No. 88-5

Overrich Acceleration “Bog” on MerCarb Equipped Models MCM 120/140/2.5L/3.0L

Carburetor Part Number Location Figure 1.

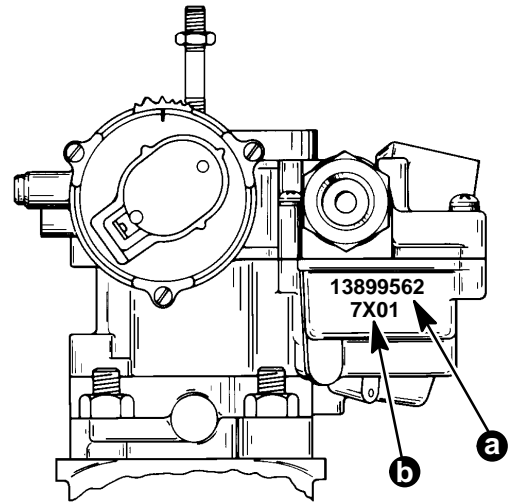
There is a new Venturi Cluster P/N 3302-9810 available to correct the “overrich bog” condition that may be encountered on these model engines equipped with Mercarbs which have the increased capacity (4cc) accelerator pump.

This new Venturi Cluster can only be used on Mercarbs, P/N 1389-9562, equipped with the increased capacity accelerator pump P/N 3322-9655.

Accelerator pumps that are modified in any way from original to correct this “boggling” condition, must be converted back to original specification and parts before the new cluster venturi is installed. Also, if a 1/4” ball was used under the accelerator pump to restrict the pumps movement, discard that ball after installing the new venturi.

Models equipped with the new cluster have day code 7X01 (Figure 1). Models and starting serial numbers with 7X01 Mercarb are 2.5L, OB923578 and 3.0L, OB923342.

Figure 2.

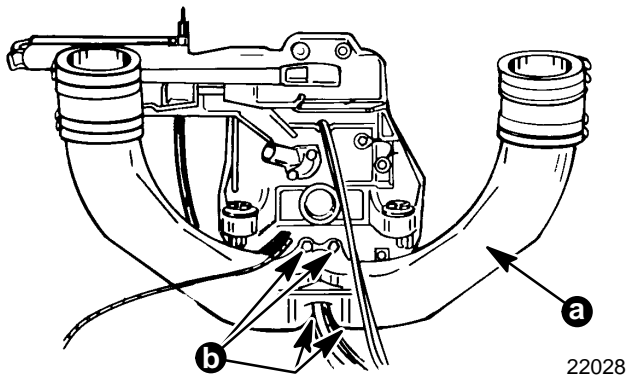
All MerCruiser V-6 and V-8 Alpha One Magnum models are now being equipped with the new Plus Power exhaust system for improved performance. The exhaust pipe on these models is now secured to the gimbal housing with 4 screws, instead of 3 (Figure 2). Early exhaust pipe installation used only 3 screws. (S/B 86-27) The additional screw has been added at the 11:00 o'clock position on new models being manufactured (Figure 2).

The torque specification for these screws is still the same as in the past -- 20–25 lbs. ft.

Figure 3.

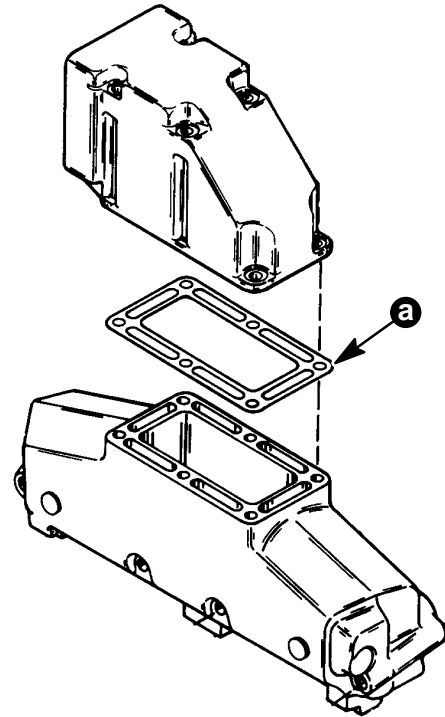
When replacing a leaking HP 420 exhaust elbow to manifold gasket P/N 27-13847 (Figure 3) coat both sides of gasket with Perfect Seal P/N 92-34227. This will prevent the water leak (weeping) from reoccurring between exhaust elbow and manifold.
